Addendum 2
Solicitation 24-99842
Upper Lakeside Water Interconnect – Phase 1

ADDENDUM #2

Project Description City of Duluth
Upper Lakeside Zone Water Main Interconnect – Phase 1

PLAN & PROFILE
Sheet Title
Sheet Number
18

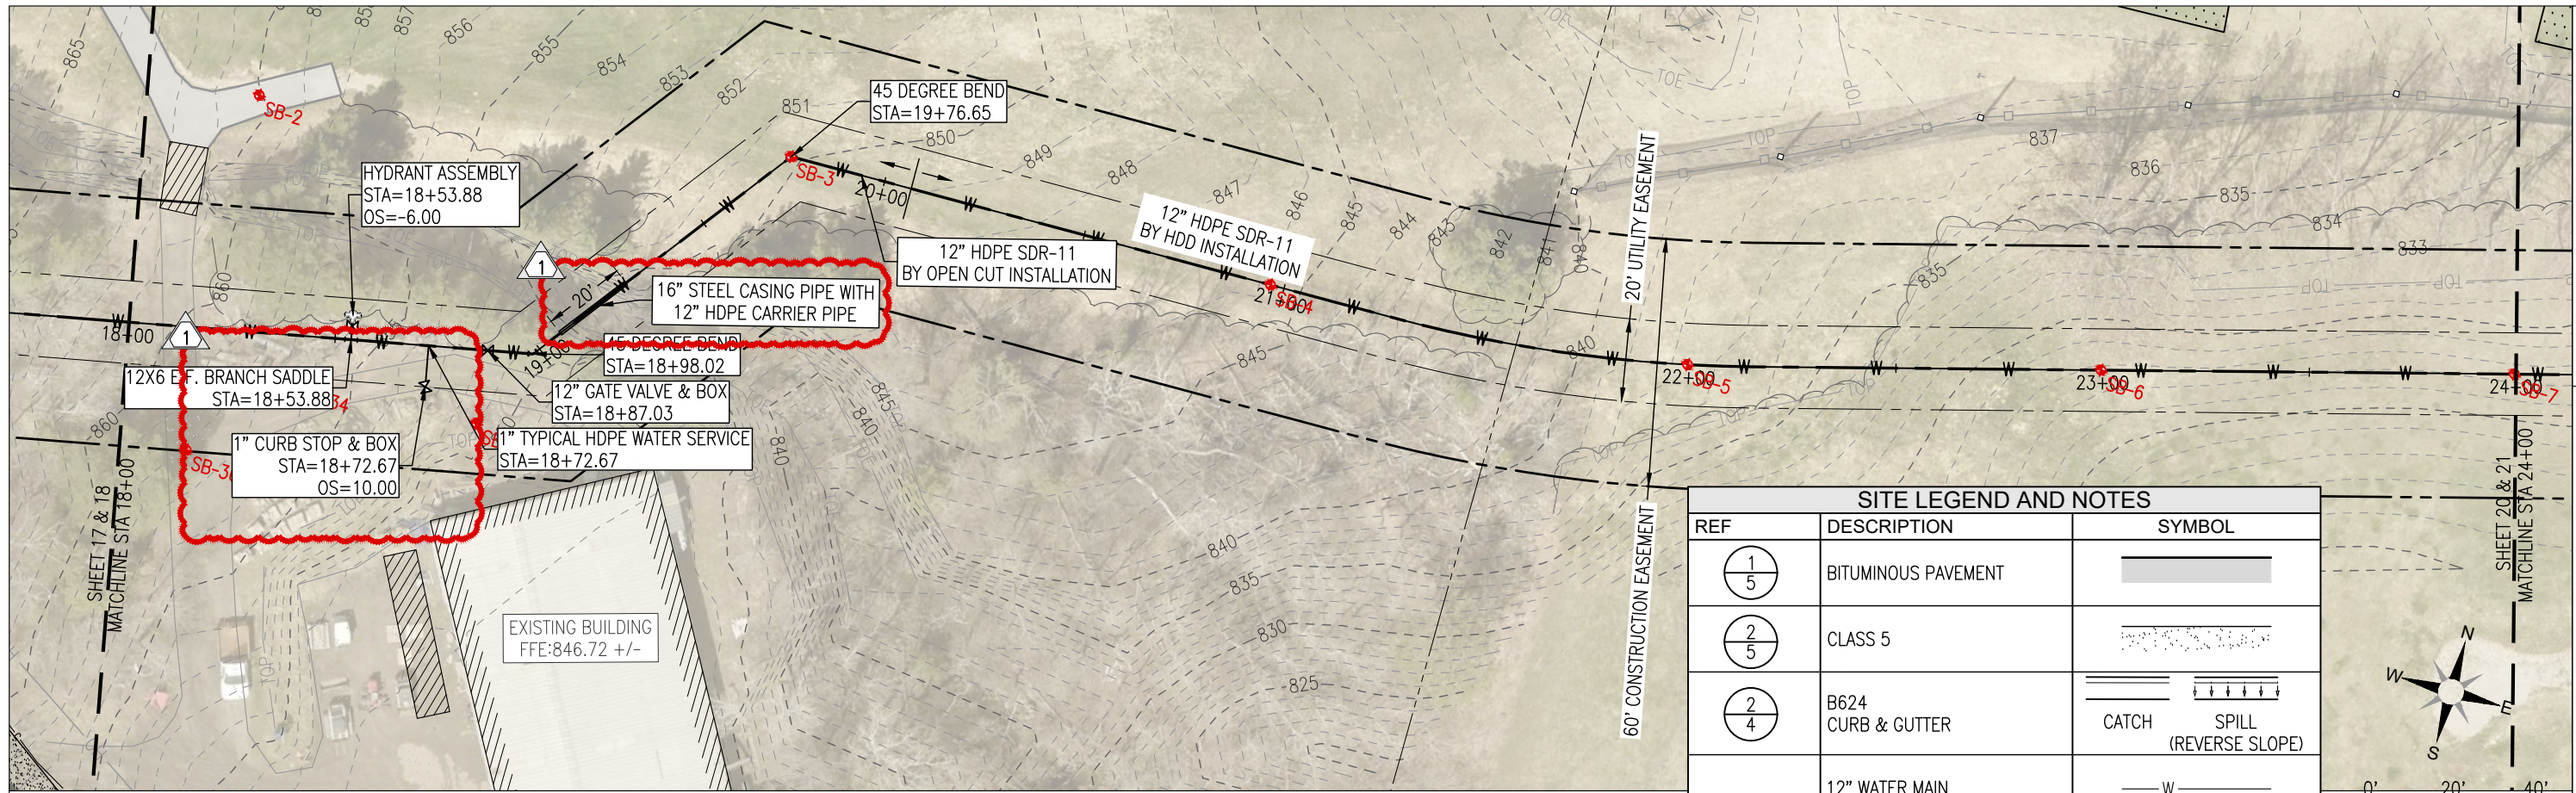
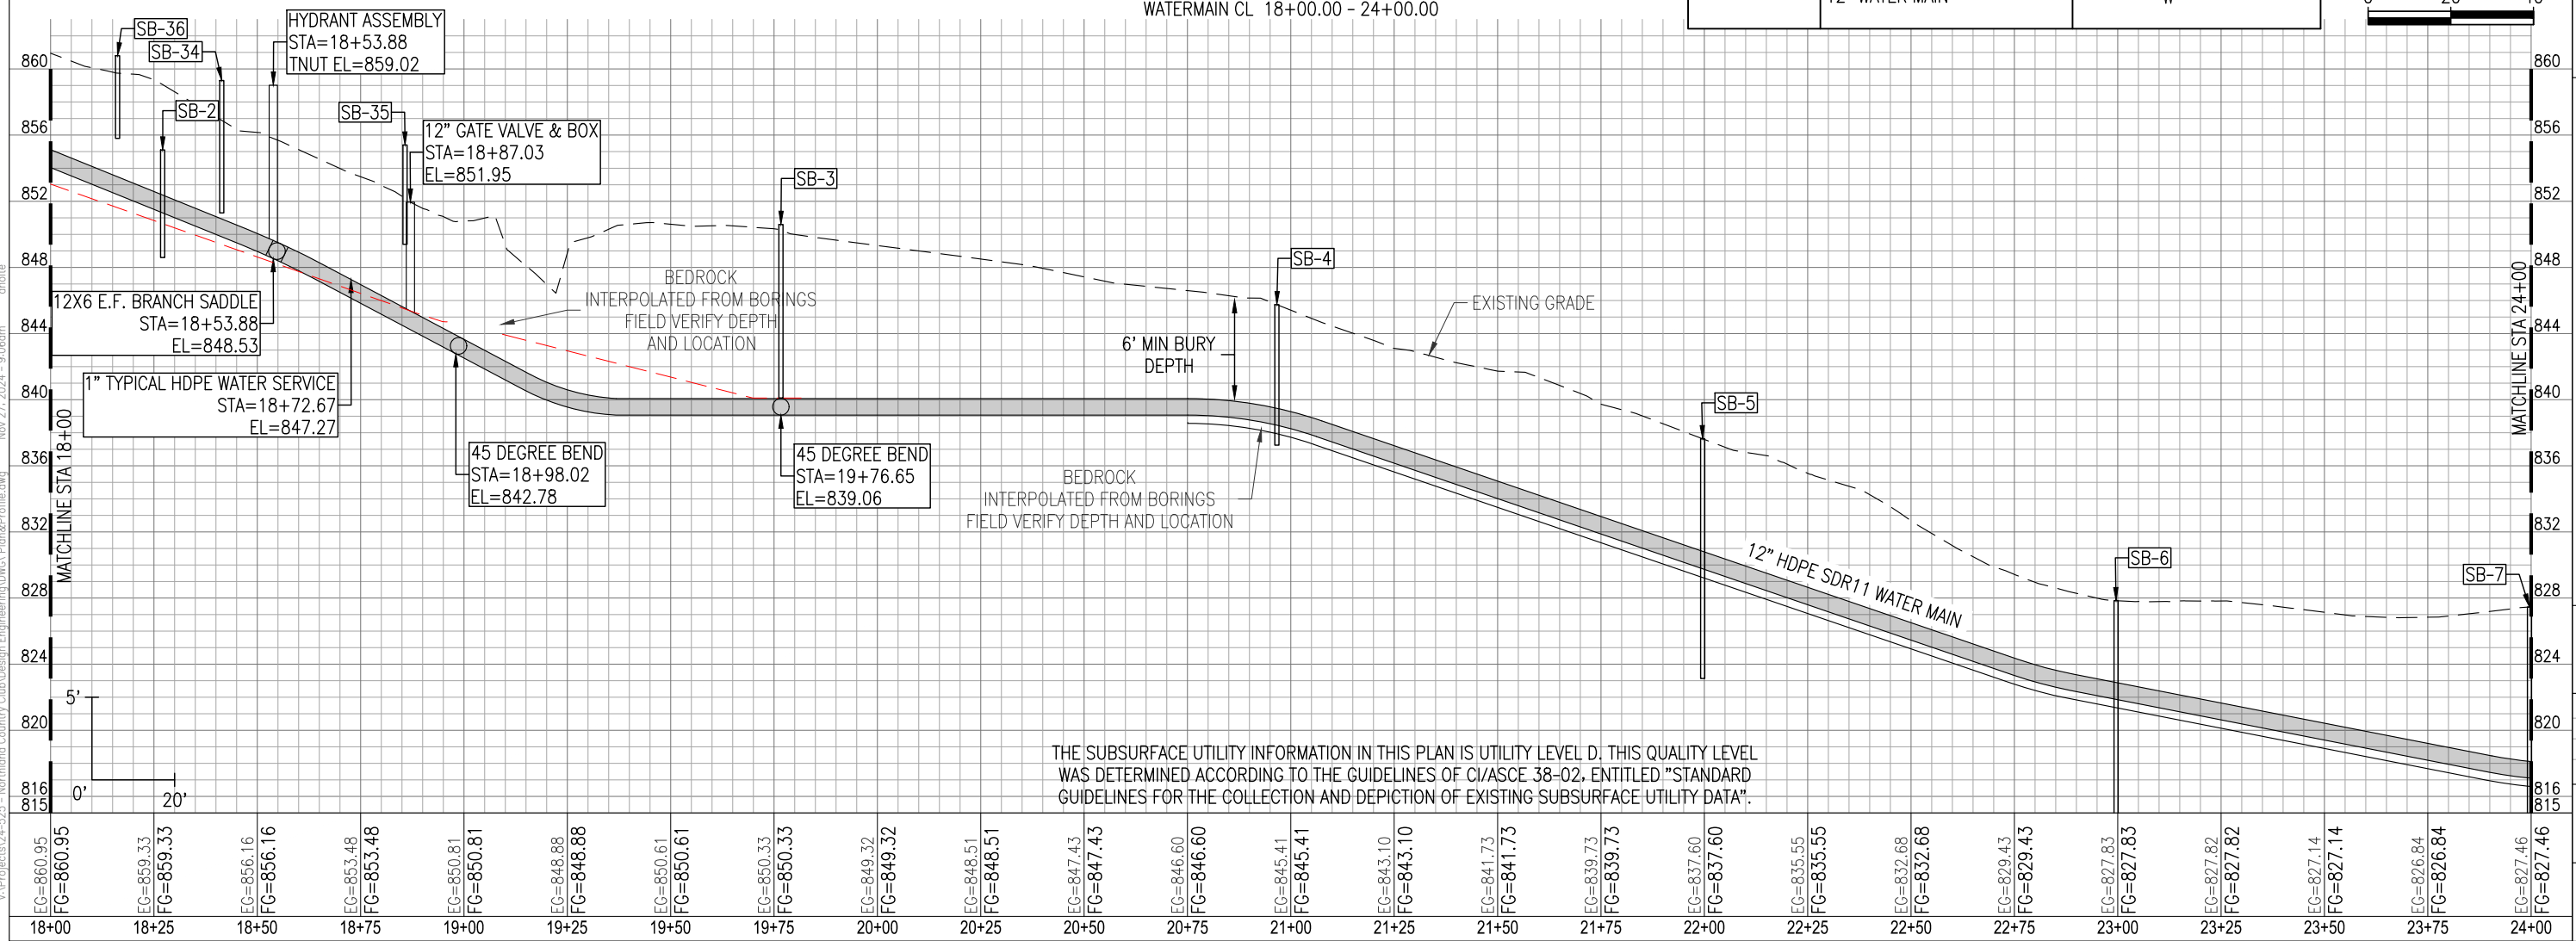
5. Sheet 16 PLAN AND PROFILE: Revised roadway profile and added 12" CAS crossing culvert.
6. Sheet 18 PLAN AND PROFILE: Updated bedrock profile.
7. Sheet 19 PLAN AND PROFILE:
